Docket Number:	23-AFC-03
Project Title:	Black Rock Geothermal Project (BRGP)
TN #:	252807
Document Title:	Black Rock Geothermal Project Data Request Response Set 2
Description:	N/A
Filer:	Jerry Salamy
Organization:	Jacobs
Submitter Role:	Applicant Consultant
Submission Date:	10/27/2023 3:24:34 PM
Docketed Date:	10/27/2023

Data Response Set 2 (Responses to Data Requests 1 to 10)

**Black Rock Geothermal Project
(23-AFC-03)
October 27, 2023**

Figure DRR 9a-1
Salton Trough Tectonic Map,
Black Rock Geothermal Project
Imperial County, California

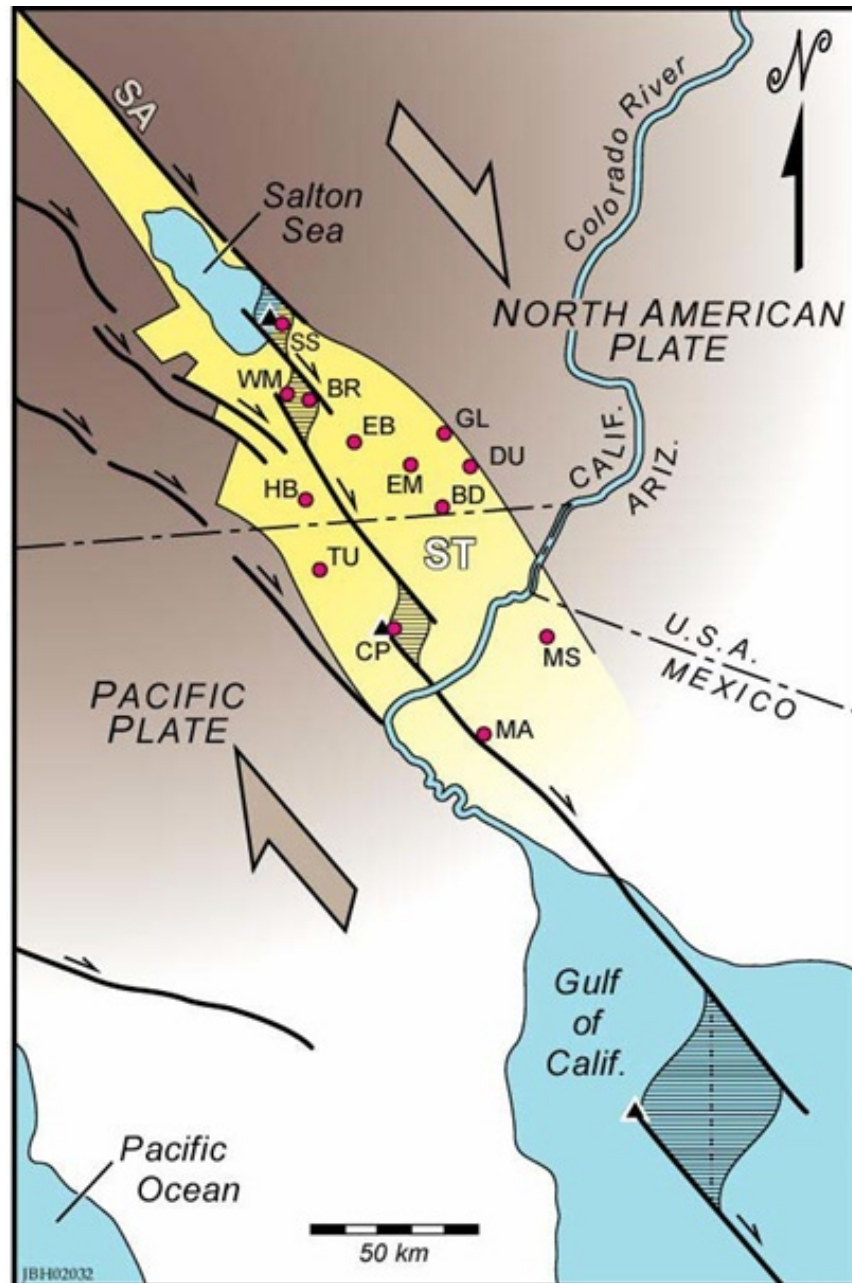
9. *To allow environmental review of the potential impacts of the whole of the project, please provide preliminary information used for planning injection well installation, as follows.*
 - a. *Known properties of the injection reservoir*

The Salton Sea geothermal reservoir occurs in fractured sedimentary rocks within the Salton Trough, a structural depression on the boundary between two tectonic plates. The northwest motion of the Pacific Plate on the west, relative to the North American Plate on the east, has created regional right-lateral faults striking NW-SE and local conjugate left-lateral faults striking NE-SW, shown as Figure 1 in the report titled "Geology and a Working Conceptual Model of the Obsidian Butte (Unit 6) Sector of the Salton Sea Geothermal Field (Hulen et al., 2003²). A copy of this figure is provided as Figure DRR 9a-1. The Salton Trough began its existence in Oligocene to Miocene time as a coaxial but smaller and shallower proto-rift, developed as a Basin and Range-style back-arc basin in response to subduction of the Farallon plate beneath the North American plate. Oligocene to Miocene basalts along the margins of the modern Trough attest to the lithospheric thinning, heating, and mafic-alkaline magmatism that accompanied the older rifting episode. The nature of the basement in the Trough remains conjectural. Gravity and seismic data suggest that low-density (2.3-2.55 g/cm³) sediments rest upon an intermediate-density (2.65 g/cm³) basement extending to about 39,000 feet depth. The intermediate basement, in turn, overlies a higher density (3.1 g/cm³) layer extending to the base of the crust at about 77,000 feet. This deep layer is inferred to be gabbro, added to the crust to compensate isostatically for the low-density sediments supplied from above (Hulen et al., 2002³).

Heat sources for the high-temperature geothermal systems of the Salton Trough have traditionally been envisioned as gabbroic. The Salton Trough is filled to a depth of approximately four (4) miles with Colorado River sediments, interbedded with salt deposits from periods of lake evaporation. Within the Salton Sea field, past volcanic activity is indicated by five outcrops of rhyolite - Obsidian Butte, Rock Hill, Red Island (North and South), and Mullet Island) - as well as extrusive and shallow intrusive igneous rocks encountered in several wells.
